Alameda Point - Site A • Waterfront Park • PHASE I

PLANNING BOARD: DESIGN REVIEW AMENDMENT | DECEMBER 09, 2019

Alameda Point - Site A:
Waterfront Park Phase I
Substantial Conformance Exhibits

PREVIOUS SITE PLAN CONCEPT

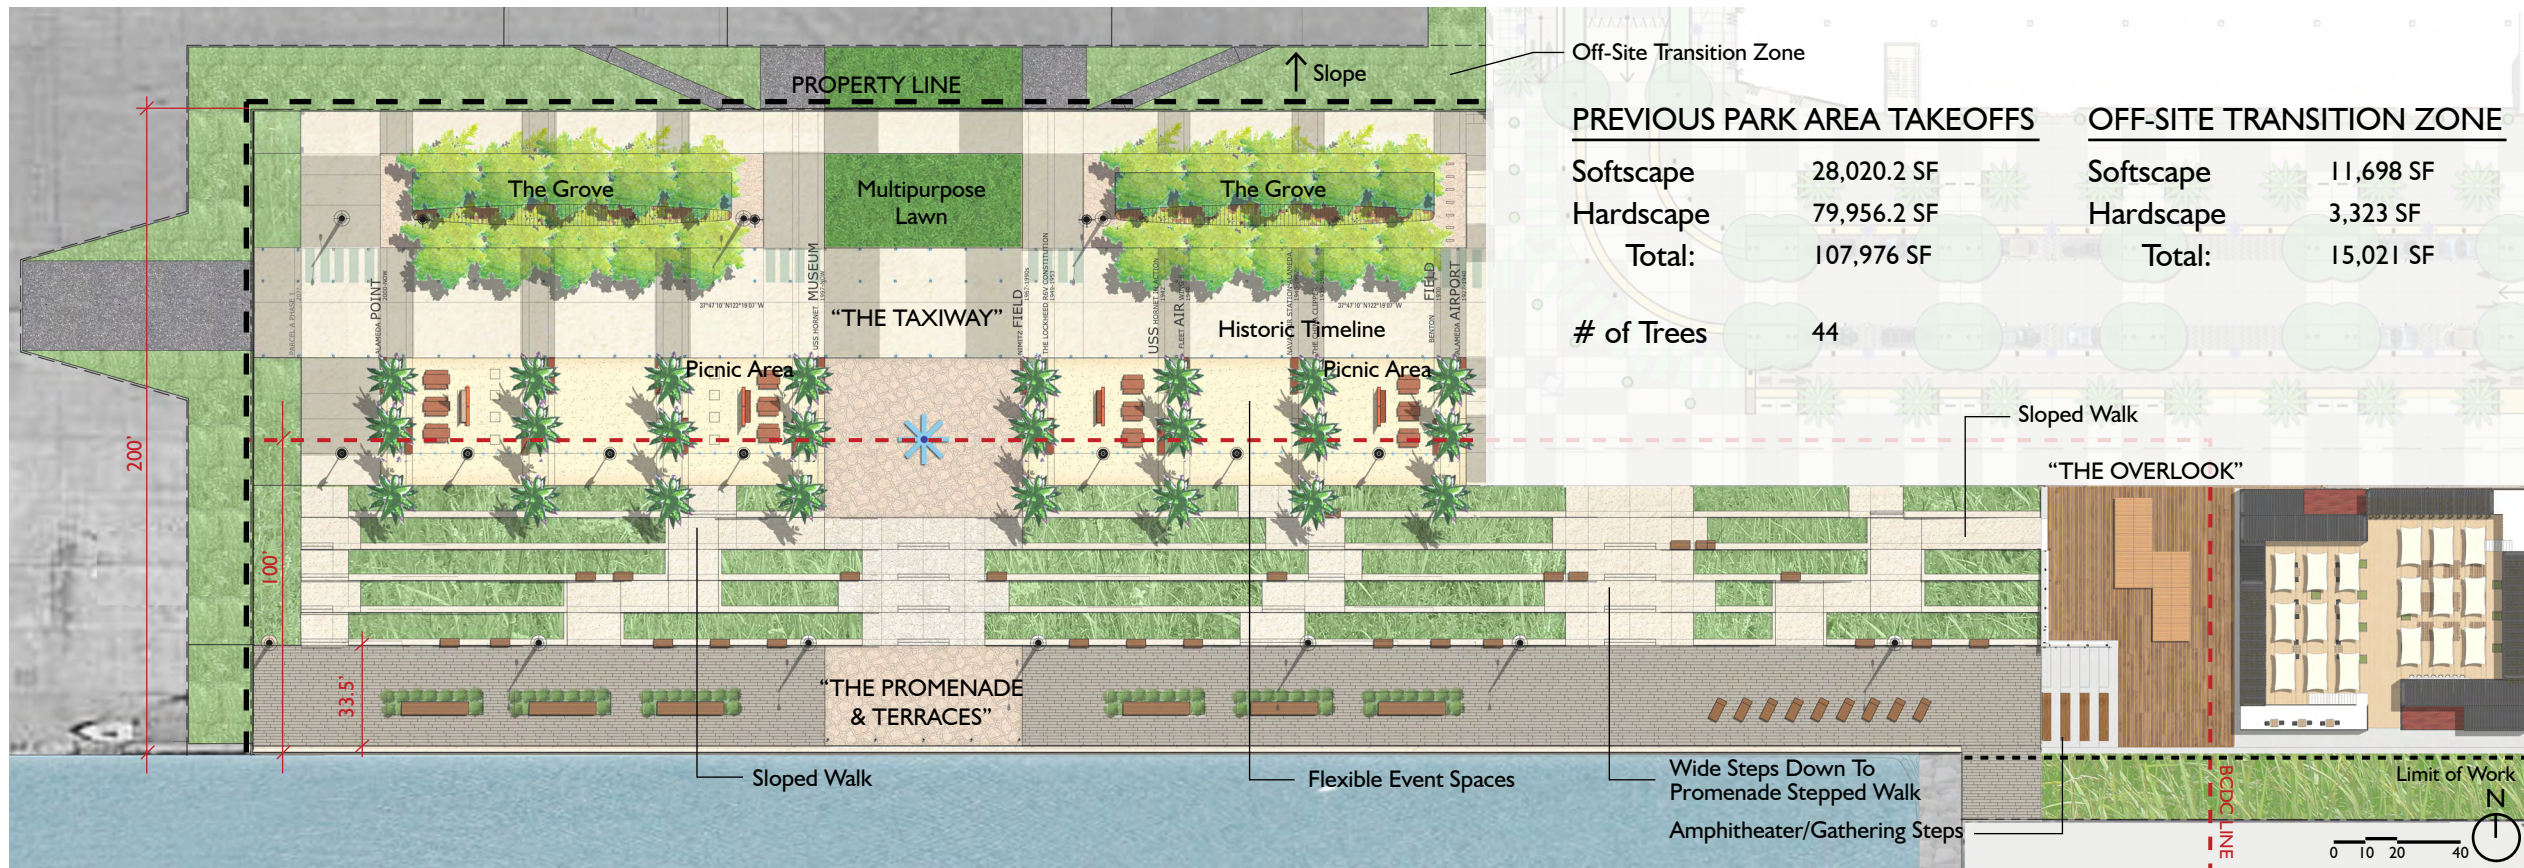
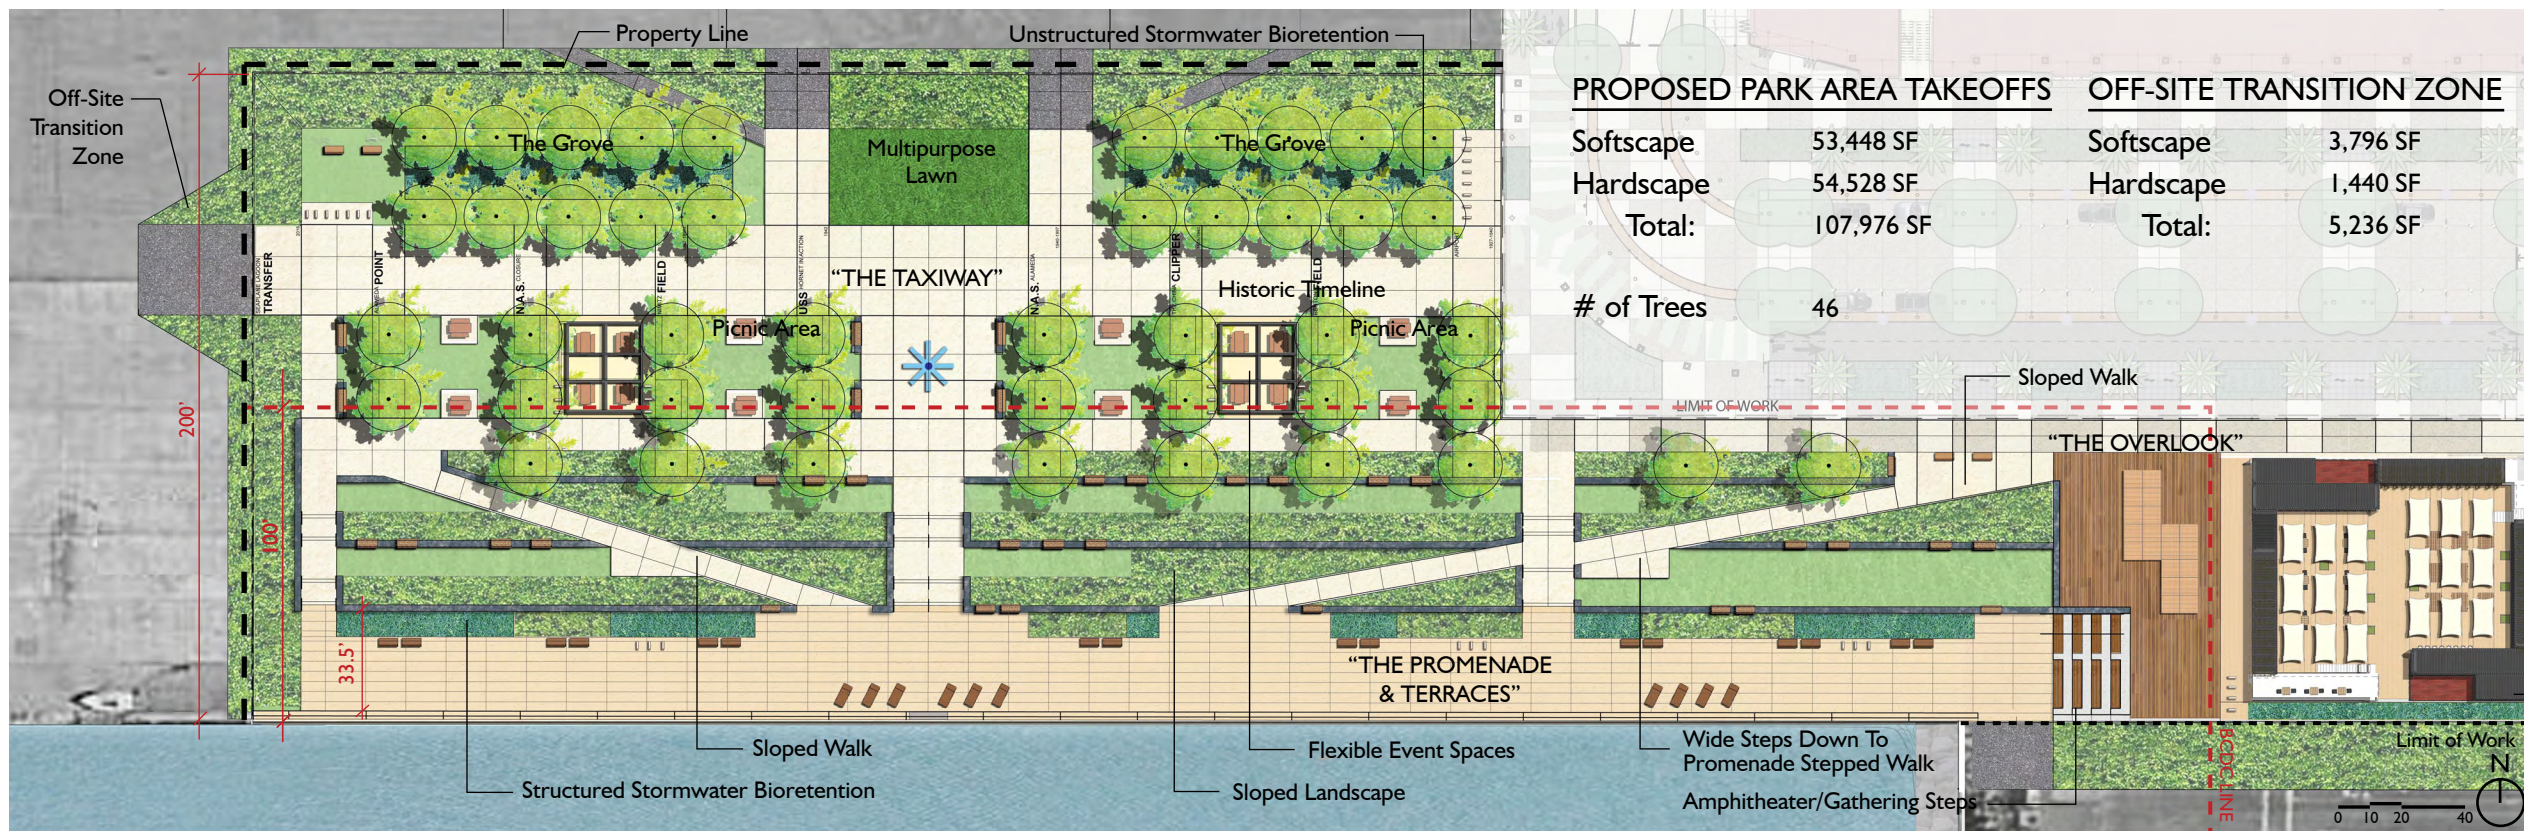
PROPOSED SITE PLAN CONCEPT

SECTION A: Through Previous Plan

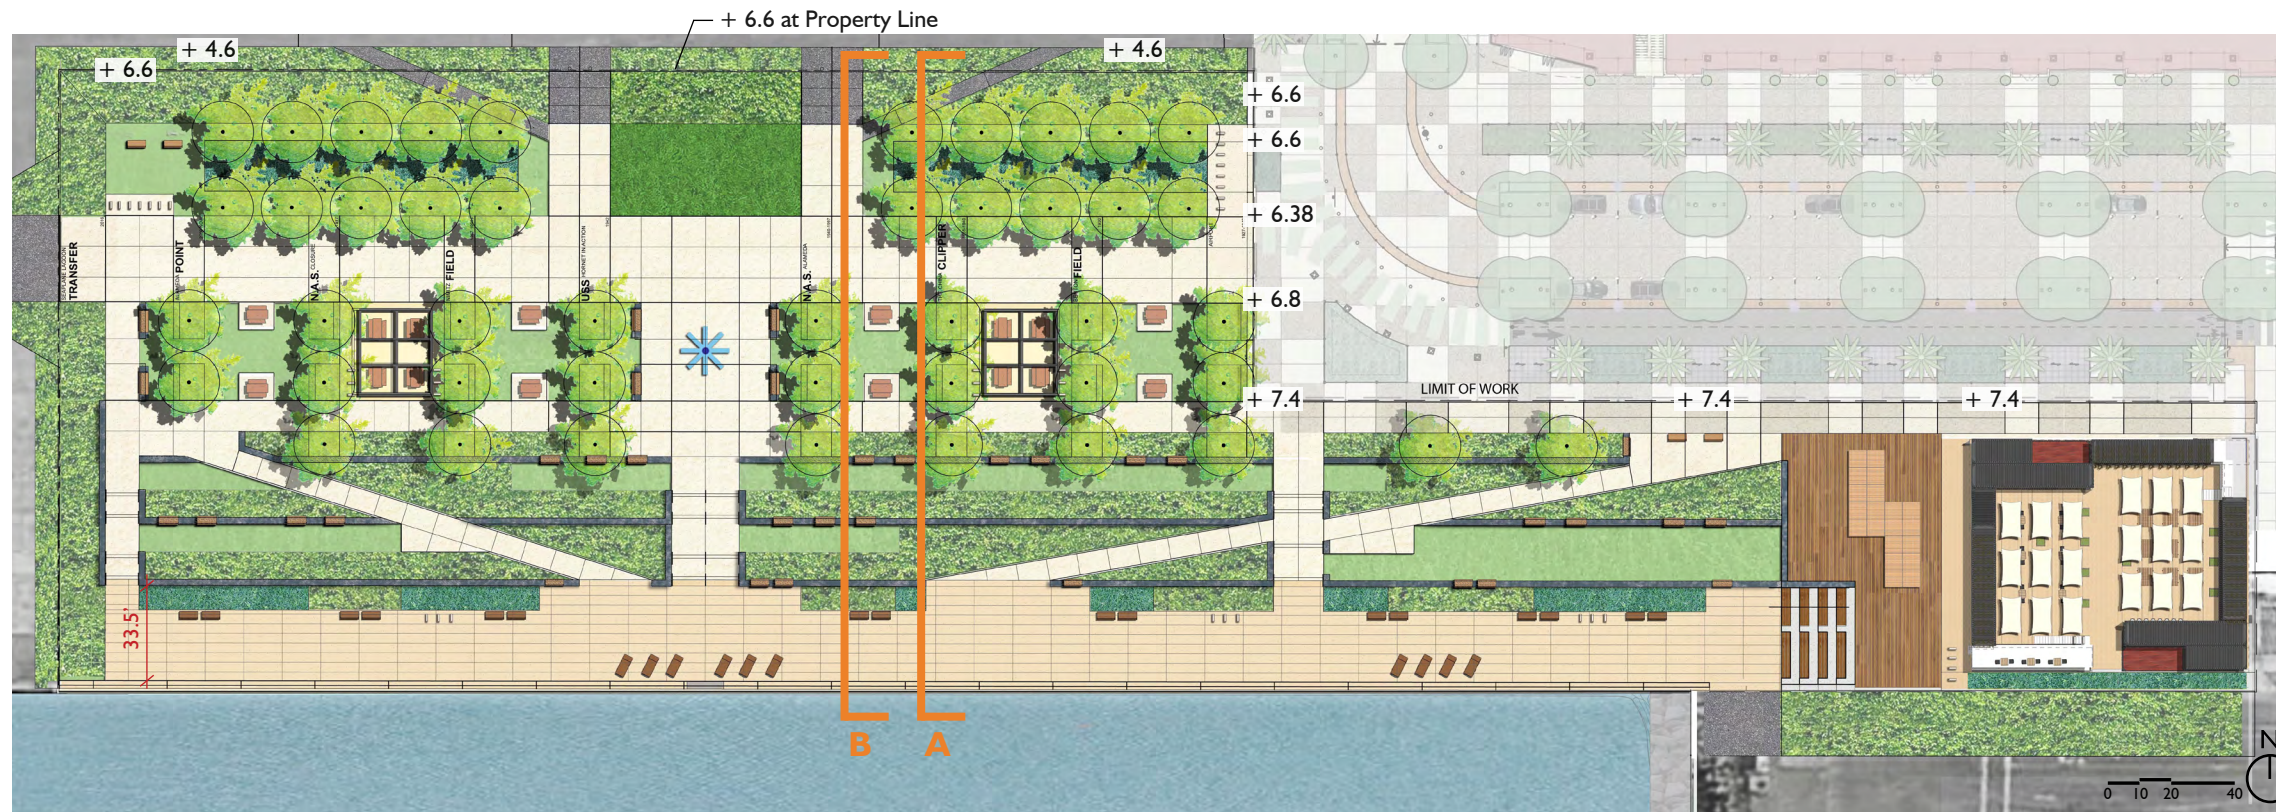
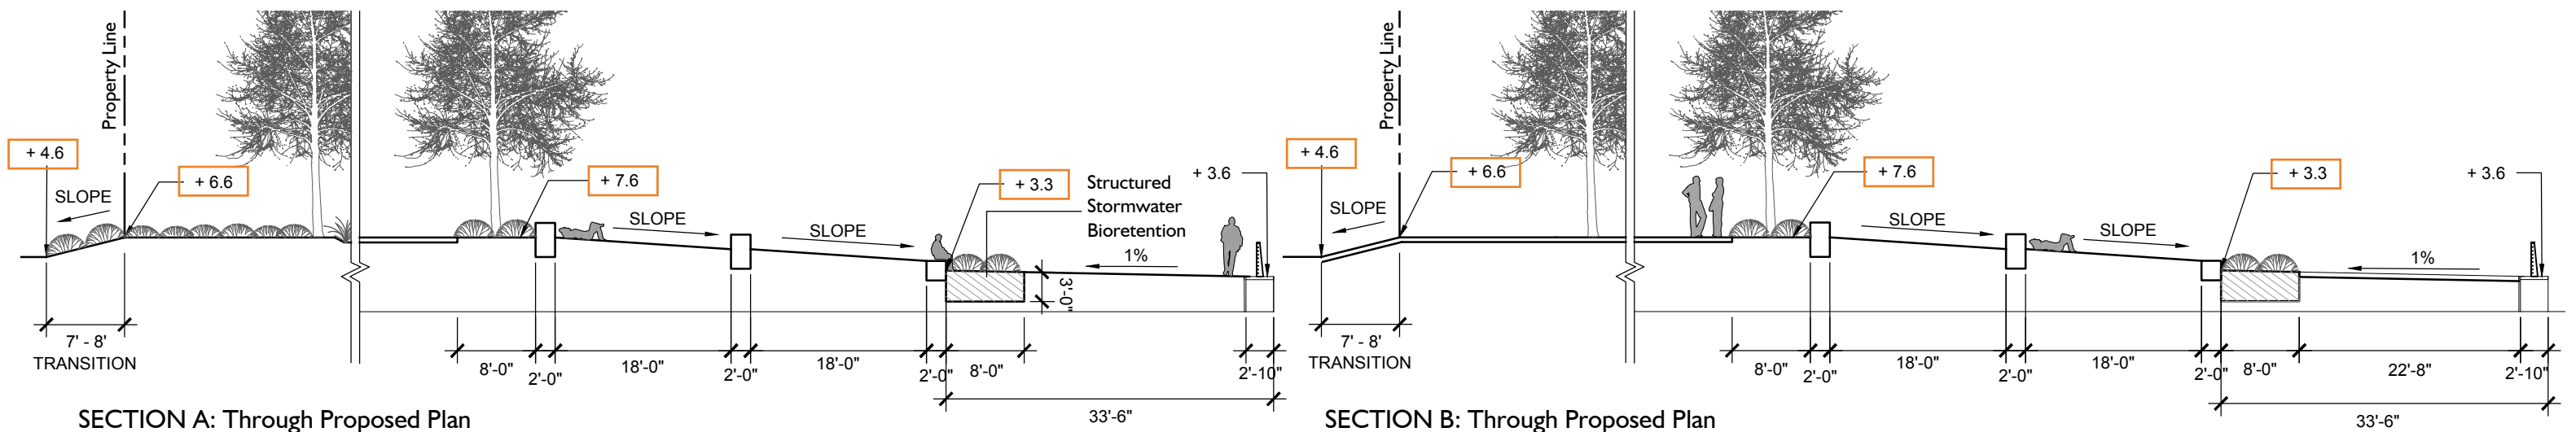
SECTION A: Through Proposed Plan

WAS THIS:

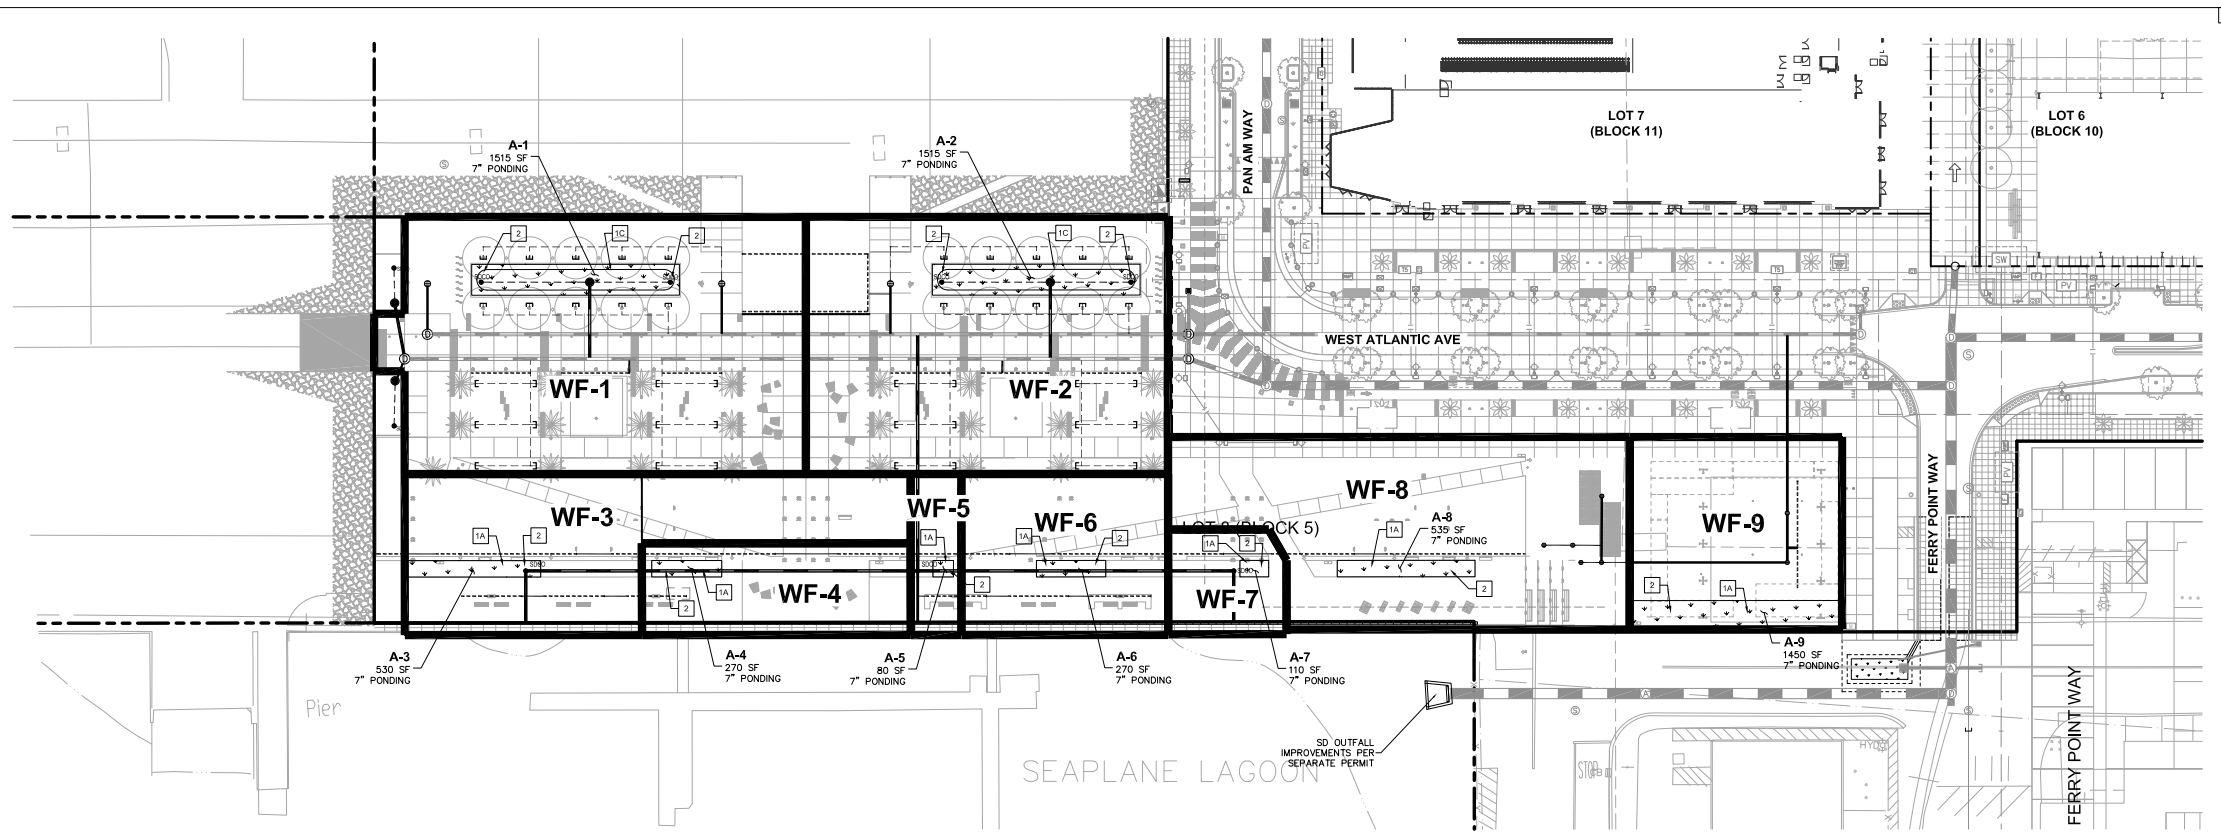
Mexican Fan Palm
Washingtonia Robusta

Washingtonia robusta
Mexican Fan Palm:

- These palms are completely suited to the coastal climate
- These palms are readily available in the quantities that we need for the Waterfront Park, but also additionally for the Shared Street and West Atlantic Drive
- They are very affordable
- These palms grow to be too tall for human scale, ultimately 90-120 feet
- They grow at 2 feet per year, so in 20 years they will be 60 feet tall

NOW THIS:

Purple Robe Honey Locust
Robinia 'Purple Robe'

Robinia 'Purple Robe'
Purple Robe Honey Locust:

- Will grow 30 - 40 feet high and 20 - 30 feet wide
- Excellent shade tree
- Has deciduous foliage
- Drought tolerant
- Suitable for seaside regions
- Fragrant flower
- Fall color
- Tree selection for Orion Street at Alameda Point
- Native
